ALERT SERVICE BULLETIN

ASB NO. 99075 NO REV. • DATE: JUNE 18, 1999 • PAGE 1 OF 7

SUBJECT: **HOIST SUPPORT INSTALLATION, LUCAS
WESTERN HOIST;
P/N 412-142-300/-350/-400**

HELICOPTERS AFFECTED: All Bell 205A-1, 212, 412, 412EP helicopters equipped with subject Hoist Support Installation.

Figure 1

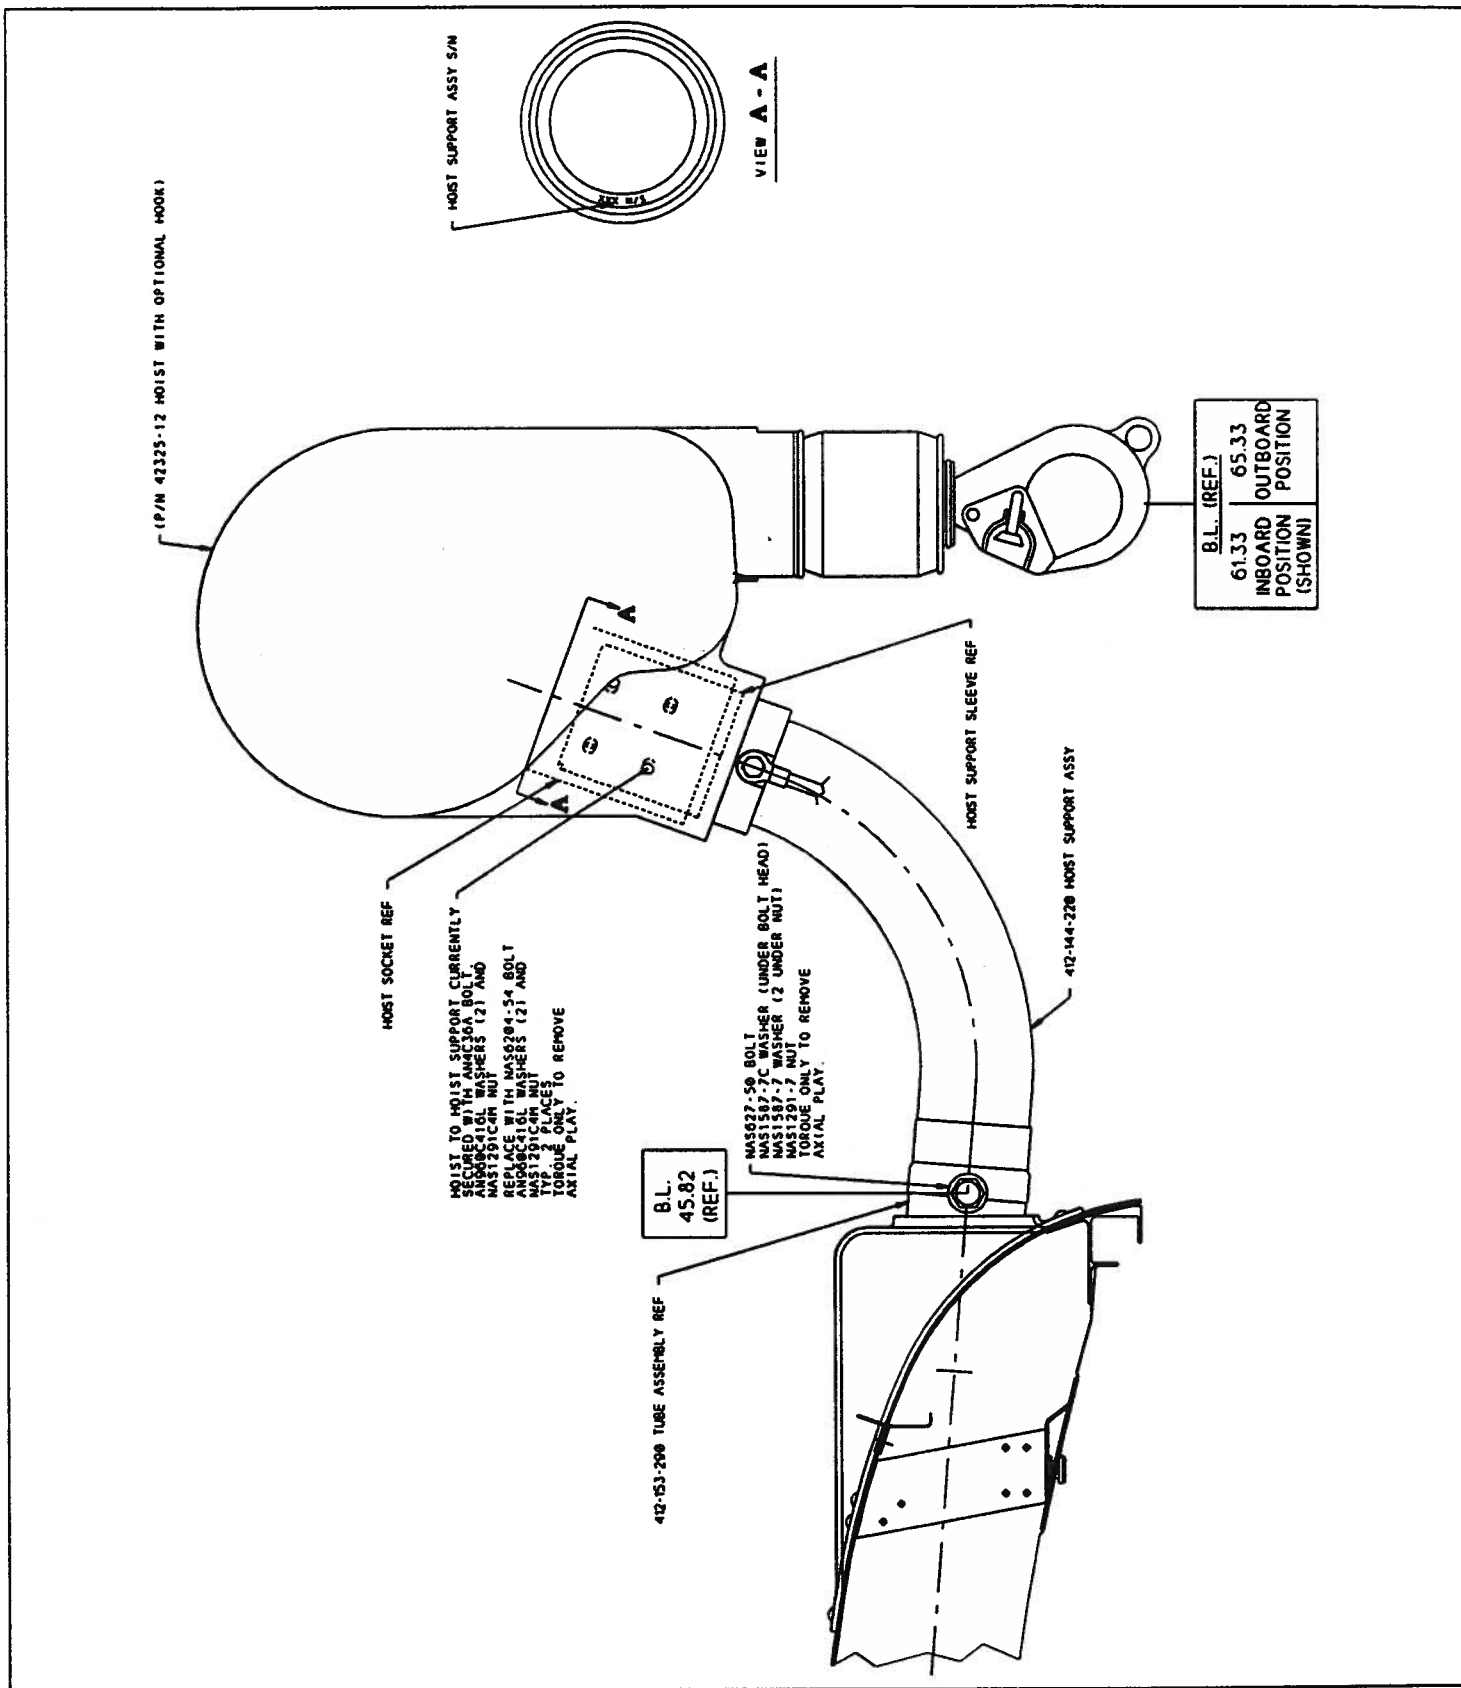
DESCRIPTION: During routine inspection of a Lucas Western External Hoist System installed on a 412 helicopter, it was discovered that one of the AN4C36 Bolts used to attach the Hoist to the Hoist Support Assembly had failed. Engineering investigation indicated that the head of the bolt was sheared due to fatigue. The redundant design of the Hoist Support Installation allowed the Hoist to function normally with only one of the two attachment bolts in place. This Alert Service Bulletin gives instructions to replace the current two AN4C36 Bolts used to attach the Hoist to the Hoist Support Assembly with increased strength NAS6204-54 Bolts. This Bulletin also gives instructions for Sealant installation between the Hoist Socket and Hoist Support Sleeve to dampen vibration.

2. Remove the Bolt (NAS627-50), Nut (NAS1291-7) and Washers (NAS1587-7C, under Bolt head), (NAS1587-7, two under Nut) securing the Hoist Support Assembly (412-144-220) to the Tube Assembly (412-153-290). Refer to Figure 1. Discard the Nut and retain the hardware remaining for reinstallation.

5. Remove the lower portion of the Hoist Fairing surrounding the Hoist Socket.
6. Remove the two Bolts, (AN4C36A) two Nuts (NAS1291C4M) and four Washers (AN960C416L) securing the Hoist to the Hoist Support Assembly. Discard the removed hardware.

7. Slide the Hoist Support Assembly out of the Hoist Socket. Record Hoist Support Assembly Serial Number (location shown in Figure 1) in appropriate section of Appendix A.

8. Clean the Hoist Socket and Hoist Support Assembly Sleeve with Isopropyl Alcohol.
9. Apply a thin (1/16 inch) layer of Sealant (MIL-S-8802 TY2 CL 1/2), provided, to the inside diameter and top of the Hoist Socket.

10. Slide the Hoist Support Assembly into the Hoist Socket and install the new Bolts (NAS6204-54), Nuts (1291C4M), and Washers (AN960C416L) provided.
11. Clean up any Sealant squeeze out with Isopropyl Alcohol.
